MIL-B-5087B(ASG)  
Amendment 2  
31 August 1970  
Superseding  
Amendment 1  
6 February 1968

### BONDING, ELECTRICAL, AND LIGHTNING PROTECTION, FOR AEROSPACE SYSTEMS

This amendment forms a part of Military Specification MIL-B-5087B(ASG), 15 October 1964, and has been approved by the Department of the Air Force and by the Naval Air Systems Command.

FIGURE 6. Fault current (Amperes)

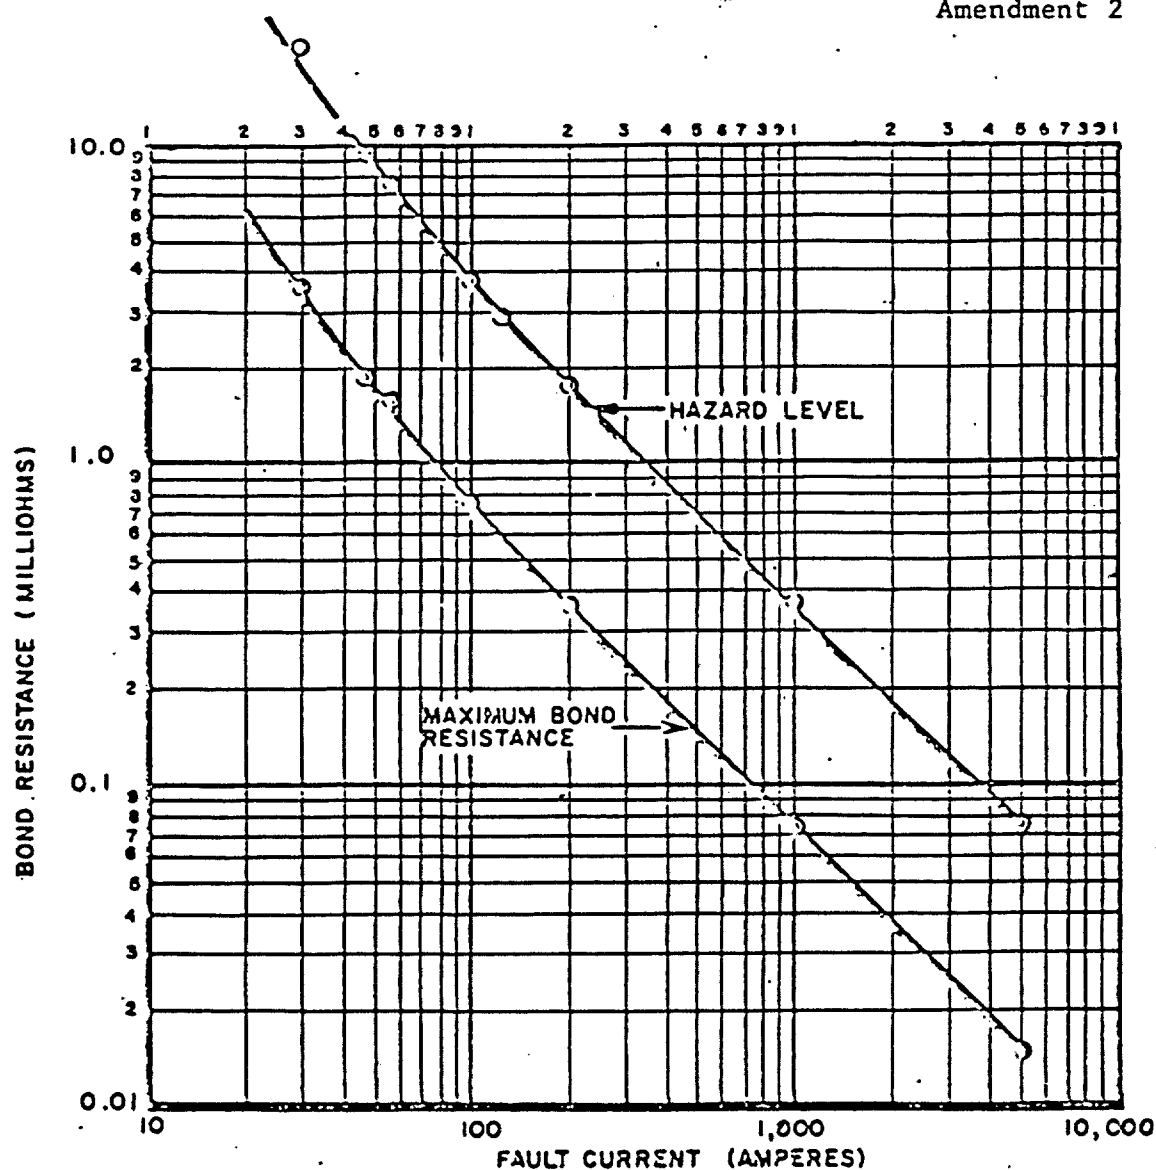
Page 13, figure 6: Delete and substitute the attached figure 6. Figure 6 forms page 3 of this amendment.

"3.3.2.4 Bonding in hazard areas. In areas prone to explosion or fire hazards; the resistance between the equipment case and structure shall not exceed the values shown on figure 6. The fault current shown is the maximum current that the electrical system is capable of delivering to the fault in the event that an internal power-to-ground fault takes place and high current passes through the equipment housing to structure. Since bonding in itself cannot eliminate all possible sources of ignition, the equipment shall be designed to minimize hot spots, sparking, and expulsion of molten metal when an internal power fault occurs.

NOTE 1. DATA POINTS

AMPS	HAZARD RESISTANCE (MILLIOHMS)	MAX RESISTANCE (MILLIOHMS)
5000	0.074	0.0143
1000	0.37	0.074
200	1.35	0.37
120	2.33	—
100	3.7	0.74
58	7.7	1.54
49	9.3	1.35
30	18	3.5
